N5173B-09

Information Only Service Note

N5173B X-Series EXG μ Wave Signal Generator

Figure 1 - Multiple self-test failures

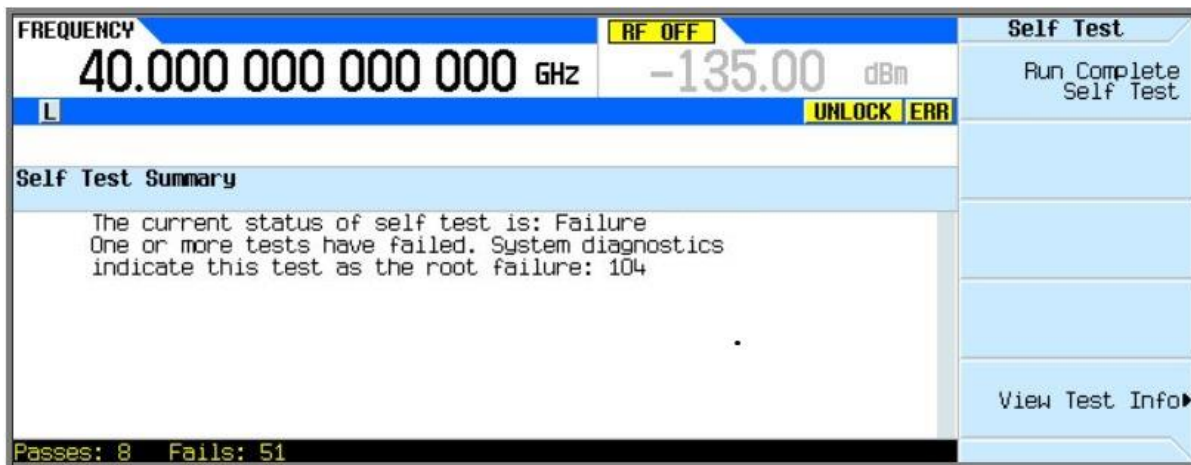
The A3 RF assemblies and A7A1 ALC control board on the A7 micro-deck were enhanced to support a new 12bit ADC for assurance of supply (AOS). Replacement of either the A3 RF Assembly, N5180-60173 with Hardware ID 000B or the A7 Micro-deck containing A7A1 ALC control board, N5180-60172 with Hardware ID 0002 will require minimum FW B.01.96 for it to operate properly. Multiple self-test failures can be observed after completing the self- test, as shown in Figure 1.

Upgrade the instrument firmware to B.01.96. Go to http://www.keysight.com/find/exg_firmware to download the instrument firmware.

Once the firmware successfully upgraded, verify that the self-test is passing on the instrument.

Figure 2 - Installed Board Information Screen

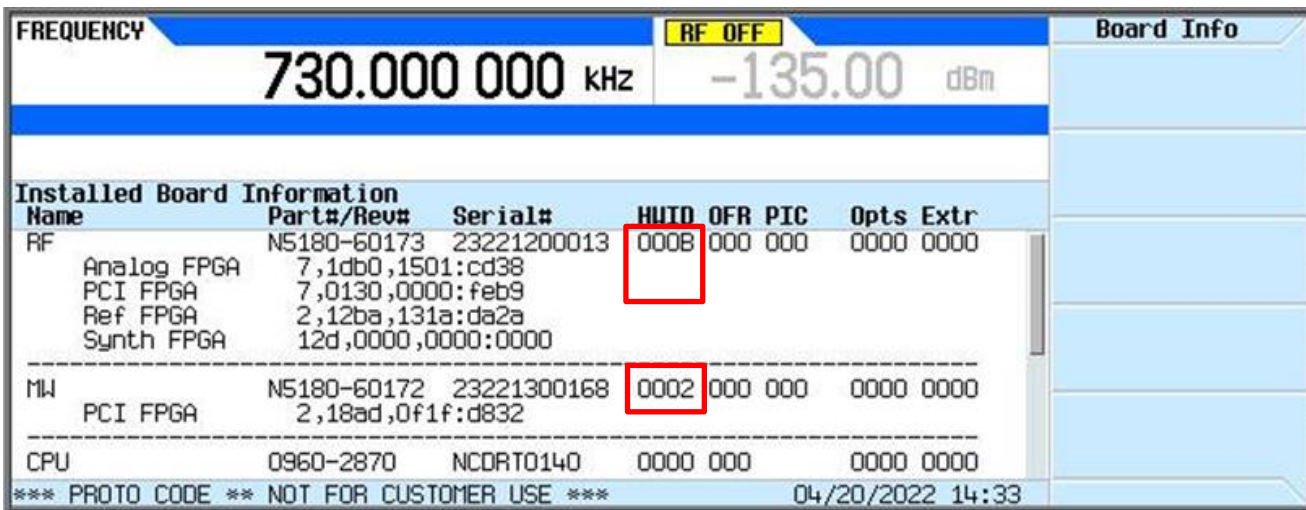
First, check that the hardware ID for the replaced assembly. This can be found on the Utility, Instrument Info, Installed Board Info screen of the instrument, as shown in Figure 2.

Figure 4 – Location of label on the ALC control board

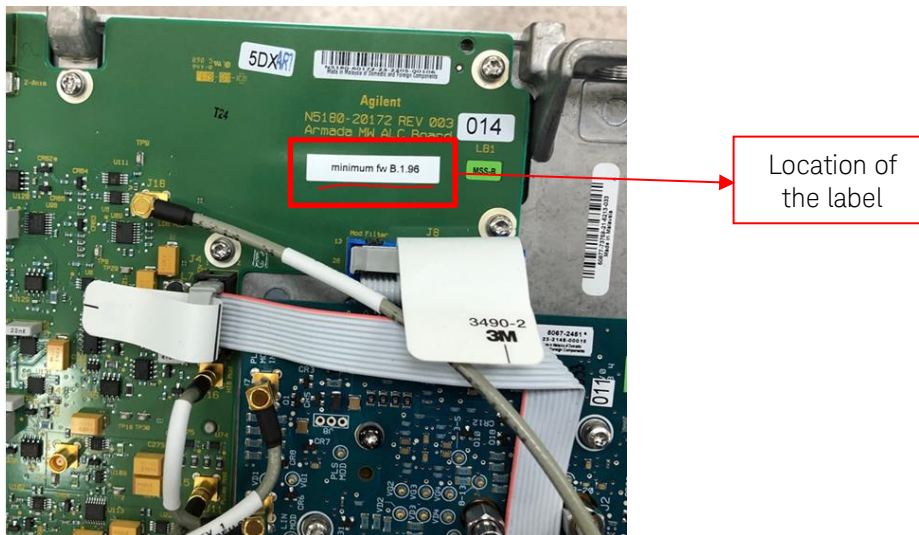
On the micro-deck, a label “minimum FW B.1.96” will be pasted on the ALC control board as shown in Figure 4.
